Scope:

This United Nations global technical regulation (UN GTR) aims at providing a worldwide harmonised method to determine the levels of Real Driving Emissions (RDE) of gaseous compounds and particles from light-duty vehicles. The results will provide the basis for the regulation of these vehicles within regional type approval and certification procedures.

Figure 2 - Definition of delay, rise, transformation and response times

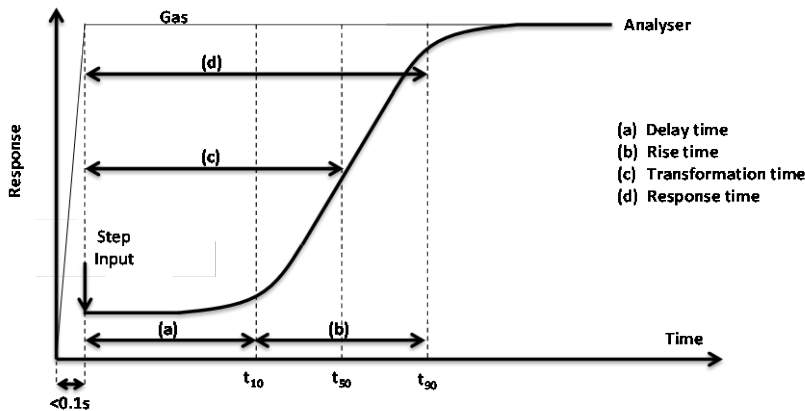
Commented [JRC-ISPRA8]: put t_0 in the figure
Important because the time alignment is based on t_0

Figure 6-2.

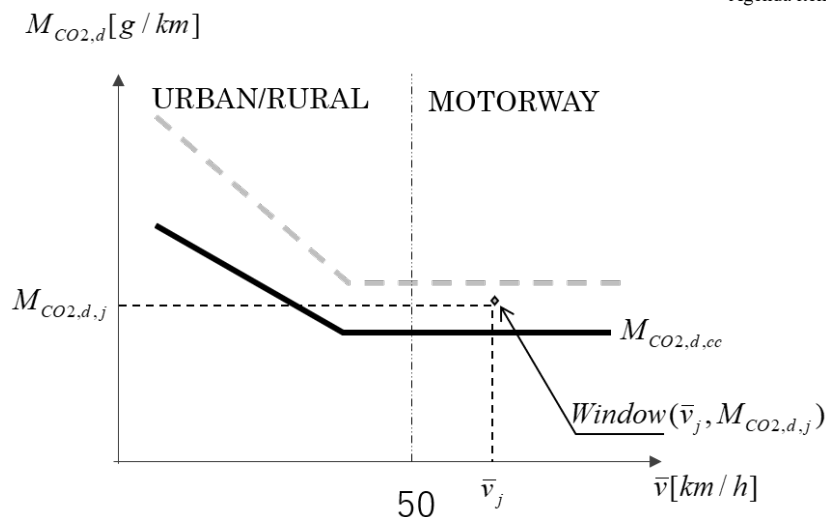
Commented [PG86]: Low speed ?

Commented [PG87]: Medium speed ?
